Field Service Bulletin

To: Users of EFJohnson Clamshell Battery for the 5100 Portable Radio

Subject: Field Modification

Clamshell cover with "Scallops" removed.

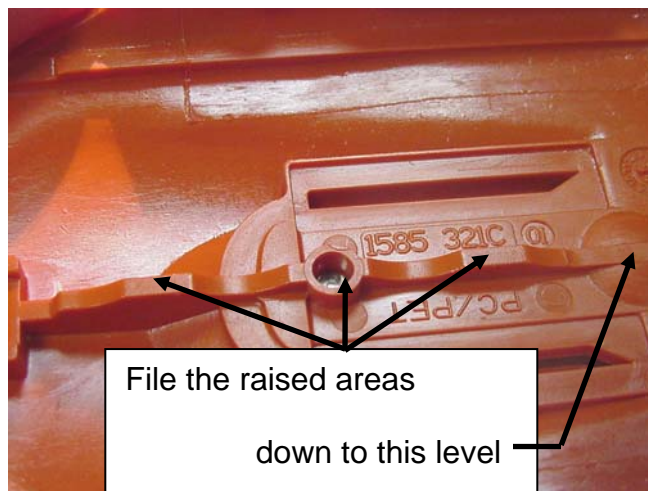
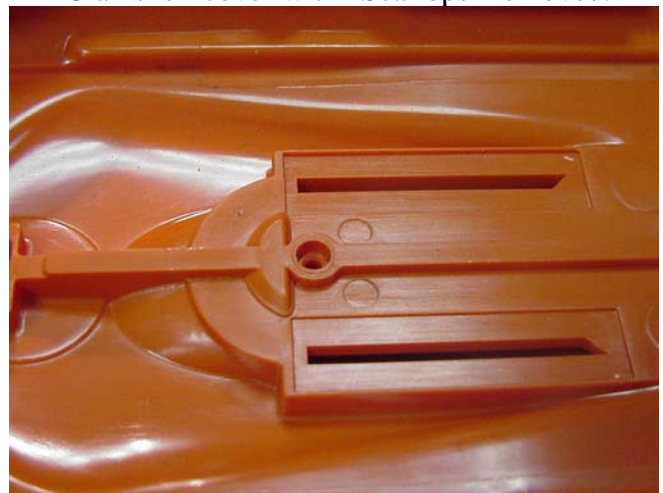
EFJohnson has received complaints that the orange clamshell battery cover can be difficult to remove under some field conditions.

The solution to this issue is to remove the scallops on the inside of the orange covers. This can be a field modification using a file or grinding tool, or the covers can be returned to the EFJohnson factory where the scallops will be ground off. Removal of the scallops does not affect the fire certification of the clamshell battery or the radio.
